**Flood Control Project Maintenance  
Levee Inspections**

**Fall 2018 Levee Maintenance Deficiency Summary Report**

**Flood Control Project Maintenance  
Levee Inspections****LMA District Cover Sheet  
Fall 2018 Levee Inspection Results****Reclamation District No. 2103 Wheatland Vicinity**

**Reclamation District No. 2103 Wheatland Vicinity**

Photo 3 of 3 : UCIP\_FA\_2018\_39986\_71880.jpg

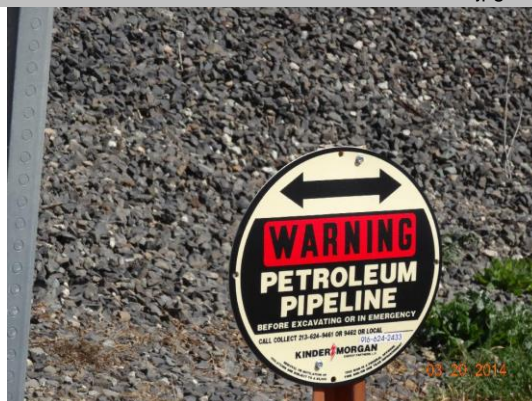
LM Start	0.54	Rating **	M	Issue No.	30 (cont)	
LM End	0.54	Issue Type +	En	Location *		
Category	Supplemental			GPS Latitude/Longitude		
				Start		End
Item	DWR UCIP Field Study			39.022514 °		39.022514 °
				-121.444814 °		-121.444814 °
DWR ID	24878

Comment Code						
Inspector Comment						
FS_ID:39986 DS_ID:24878 EP_NO: N/A Repair Type: Non-Urgent Crossing Status: Indicator Found UCIP Comments: It appears this is the same line as the next entry however, permit calls for Southern Pacific Pipe Lines, Inc as the owner and the sign found in the field indicates Kinder Morgan as owner. Need to contact owner to clarify if 2 crossings exist or if crossing is same owner will need to update permit information. Also need to contact owner to determine status of crossing. Need date of last inspection and confirmation that crossing is still in operable condition. FIELD_STRUCT_DESC: Kinder Morgan line through levee. Markers visible on both banks. FS Date: 3/4/2014

Petroleum Pipeline owned by Kinder Morgan.

Photo 1 of 3 : UCIP\_FA\_2018\_40049\_71928.jpg

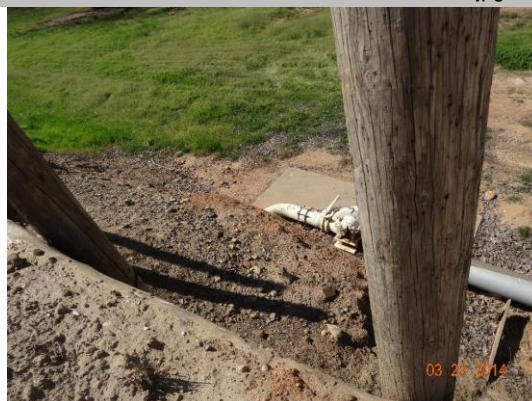
Comment Code					
Inspector Comment					
FS_ID:40049 DS_ID:19493 EP_NO: N/A Repair Type: Non-Urgent Crossing Status: Found UCIP Comments: 03/20/2014 Crossing has been modified---need to contact owner to obtain permit used for modification. (O. Magana - DWR UCIP) FIELD_STRUCT_DESC: 24-inch corrugated metal irrigation pipe through levee, 10.6 feet below the crown. Slide gate in concrete square riser (not 36-inch CM riser as mentioned in desk study) is located on the waterside (WS) slope. Concrete "U" headwall and trash rack on WS toe. 5-foot by 5-foot concrete distribution box and headwall located on the landside (LS) toe. [Additional Reference(s): DWR Levee Logs, 2005. USACE Sacramento O&M Manual Unit No. 146, November 1962, (HLM 4.87)] FS Date: 3/20/2014

Pipe visible on waterward side.

Comment Code						
Inspector Comment						
FS_ID:40049 DS_ID:19493 EP_NO: N/A Repair Type: Non-Urgent Crossing Status: Found UCIP Comments: 03/20/2014 Crossing has been modified---need to contact owner to obtain permit used for modification. (O. Magana - DWR UCIP) FIELD_STRUCT_DESC: 24-inch corrugated metal irrigation pipe through levee, 10.6 feet below the crown. Slide gate in concrete square riser (not 36-inch CM riser as mentioned in desk study) is located on the waterside (WS) slope. Concrete "U" headwall and trash rack on WS toe. 5-foot by 5-foot concrete distribution box and headwall located on the landside (LS) toe. [Additional Reference(s): DWR Levee Logs, 2005. USACE Sacramento O&M Manual Unit No. 146, November 1962, (HLM 4.87)] FS Date: 3/20/2014
